Proposed Amendment No. 67  
05/30/85

8506070554 850530  
PDR ADDCK 05000305  
P PDR

FIGURE TS 6.2-2

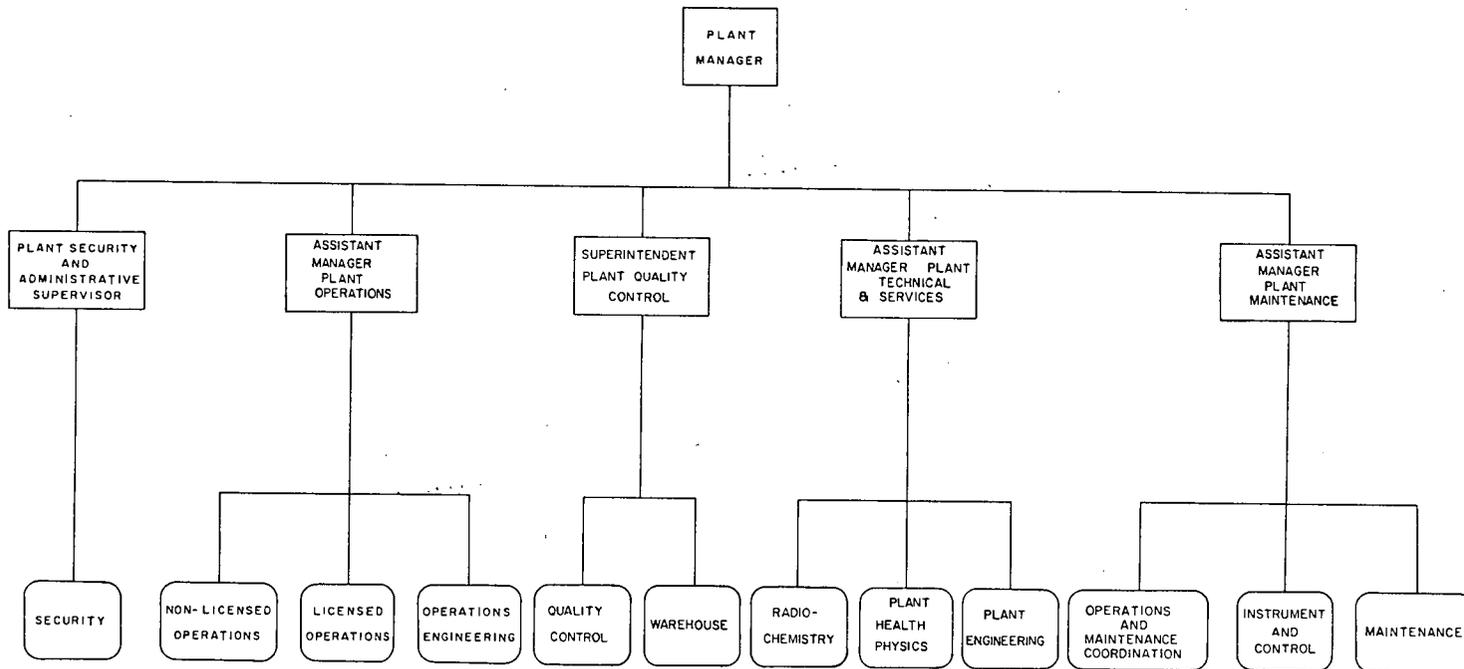
6.2.2 The plant organization shall be as shown on Figure TS 6.2-2 and:
